MFN No. 081-92
Docket No. STN 52-001
SLK-9249

Subject: **GE Responses to the Resolution of Issues Related to Chapter 15 of
ABWR DSER SECY-91-355**

Enclosed are thirty-four (34) copies of the GE responses to NRC staff comments and to Outstanding Issues 136 and 139. In addition, the test has been revised to incorporate the response to Outstanding Issue 135 provided in the referenced letter.

Feedwater Controller Failure - Maximal Demand
Figure 15.1-3 ~~RUNOUT OF TWO FEEDWATER PUMPS~~

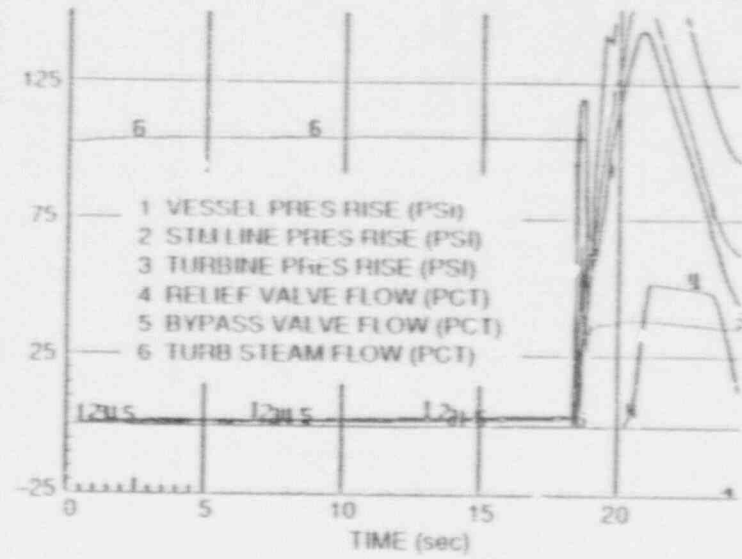
With excess feedwater flow, the water level rises to the high-level reference point, at which time the feedwater pumps and the main turbine are tripped and a scram is initiated. Table 15.1-5 lists the sequence of events for Figure 15.1-3. The figure shows the changes in important variables during this transient.

The simulated runout of ~~two~~ ^{all} feedwater pumps ~~event~~ is shown in Figure 15.1-3. The high water level turbine trip and feedwater pump trip are initiated at approximately 18 seconds. Scram occurs and limits the neutron flux peak and fuel thermal transient so that no fuel damage occurs. It is calculated that the MCPR is right at the safety limit. Therefore, the design limit for the moderate frequent incident is met. The turbine bypass system opens to limit peak pressure in the steamline near the SRVs to 82.8 kg/cm²g and the pressure at the bottom of the vessel to about 84.9 kg/cm²g.

Figure 15.2-16 SLOW CLOSURE OF ONE TURBINE CONTROL VALVE

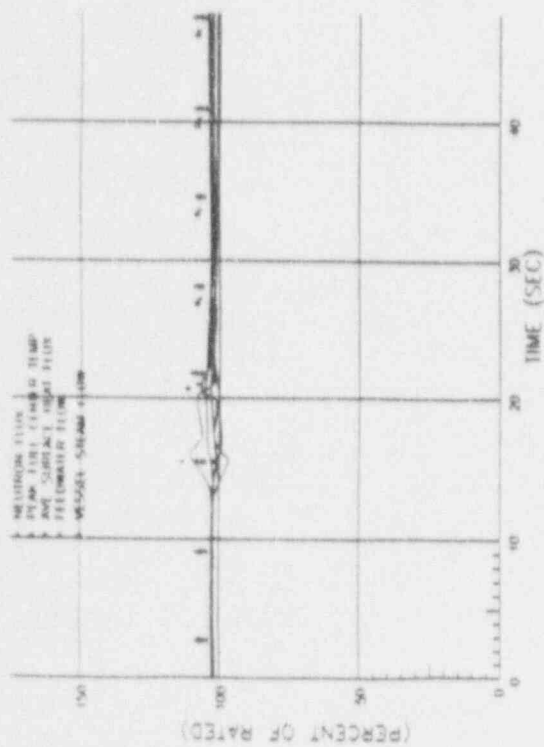
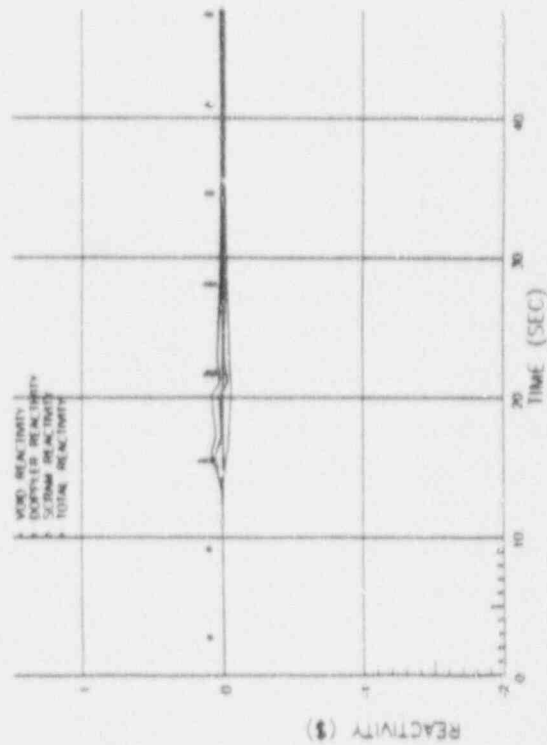
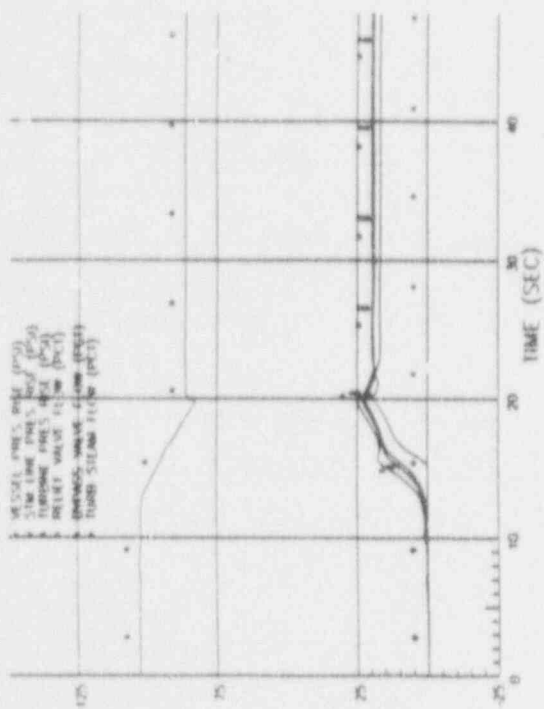
A slow closure of one turbine control valve is also analyzed as shown in Figure 15.2. -1b. In this case, the neutron flux increase does not reach the high neutron flux alarm setpoint. Since the available turbine bypass capacity is high enough to bypass all steam flow not passing through remaining three turbine control valves, the reactor power settles back its steady state. During the transient, the peak fuel surface heat flux does not exceed 103.6% of its initial value. MCPR is still above the safety limit ($\Delta CPM = 0.09$). Therefore, the design basis is satisfied.

Replaced with the new figure.

Figure 15.3-2a cladding Temperature during
All pump Trip

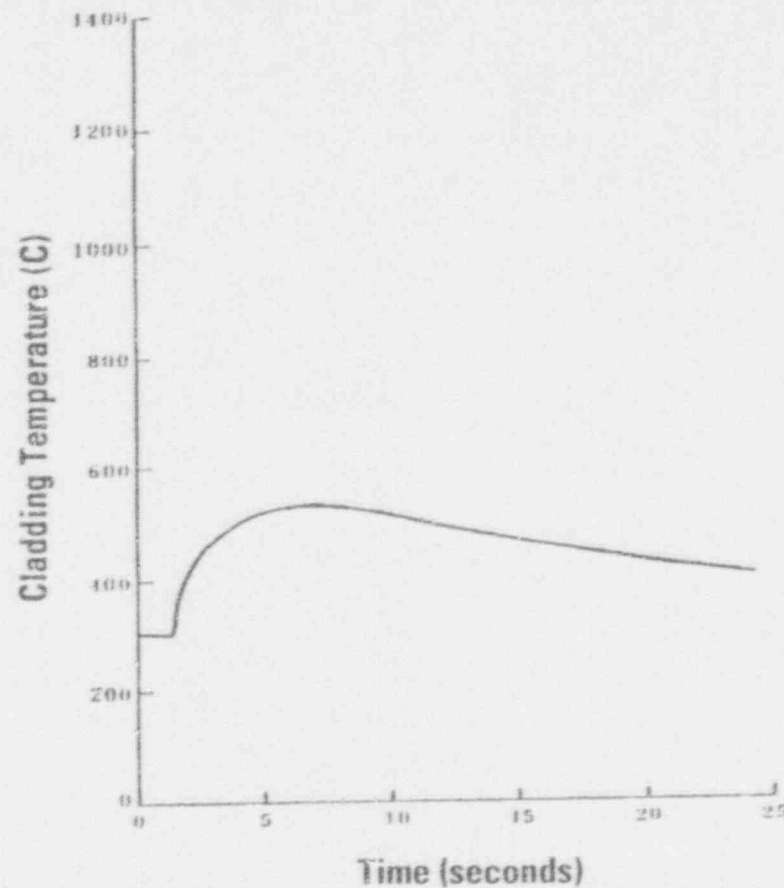
The cladding temperature during this event is shown in Figure 15.3-2a. Since the time that the cladding temperature is above the coolant saturation temperature is less than 60 seconds, and the peak cladding temperature is less than 600°C , no fuel failure is expected.
